Summary	Changing the mounting for wireless antenna on Turbo Seals with mount side blowers.				
Products Affected	Turbo Seal Freezers with blowers and wireless bottom bars				
Key Word Tags					
Tools/Equipment (If Required)					
Parts/Materials (If Required)					
Related Media					
Author	Jeff Bossert, RevA M. Burzlaff	Issue Date	4/28/2009	Status	Active

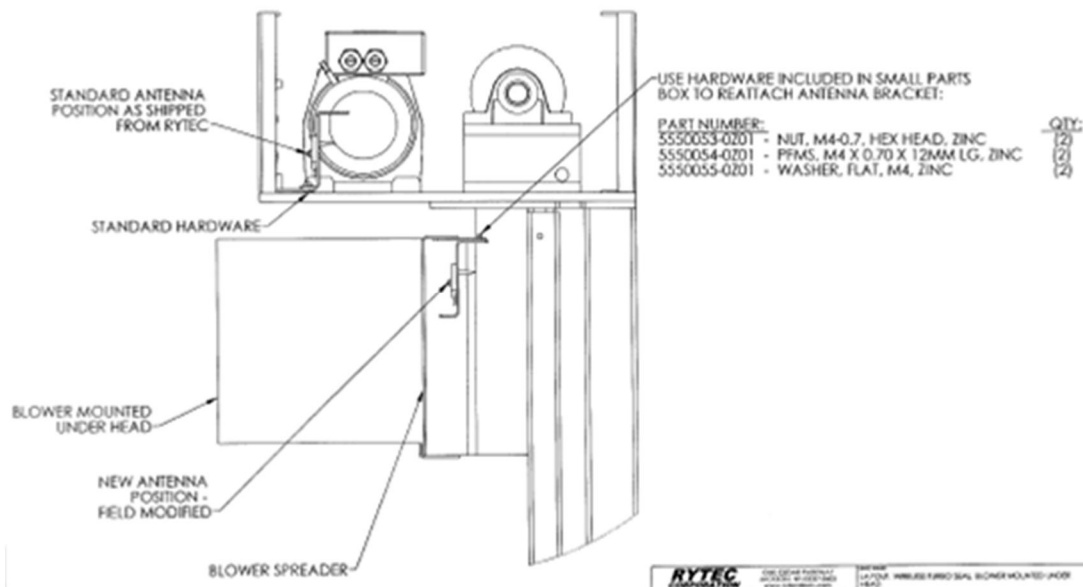
Moving the antenna on a Turbo Seal will only apply to doors that have front clearance issues with the blower. What we do in this case is raise the overall height of the door to allow the blower to mount directly under the head without affecting the door opening height. (see figure 1.) When the blower is mounted under the head on a wireless door it will block the line of sight between the mobile unit and the antenna. The antenna will need to be moved to the blower bracket to allow the two to communicate properly. The antenna will be mounted in the standard location for shipping purposes.

- 1) Once the door is installed, remove the antenna from the standard mounting position.
- 2) Attach the antenna to the bottom side of the new mounting position using tapered head bolts in the small parts bag. It is critical to the communication to have a flat surface on the top flange of the antenna bracket.
- 3) Make sure that the copper colored wire between the encoder and antenna is not kinked or pinched.
